**GAZCORP INDUSTRIAL ESTATE – 813-913 WALLGROVE ROAD, HORSLEY PARK
SSD-5248 – MODIFICATION 7 REQUEST FOR ADDITIONAL INFORMATION**

This letter is submitted to the Department of Planning, Housing and Infrastructure (DPHI) in response to a request for additional information dated 20 August 2025.

Figure 1 Asset Protection Zones

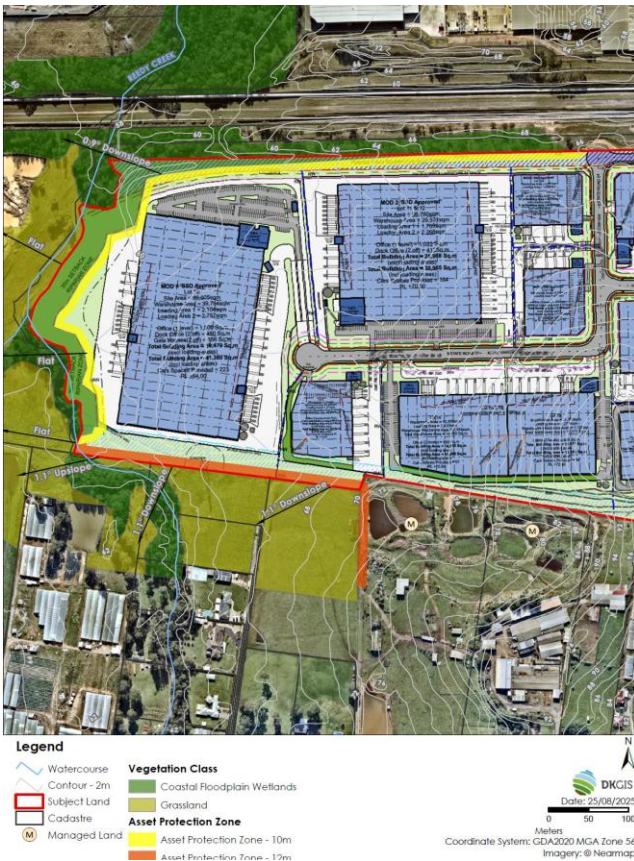
Based on the information provided, it is recommended that the subsequent stage of the referral be supplied with a bush fire report prepared by a suitably qualified bush fire consultant addressing the relevant sections of Planning for Bush Fire Protection 2019.

Asset Protection Zones (APZs) are shown at **Figure 1** and the Bushfire Attack Levels (BAL) are shown at **Figure 2**.
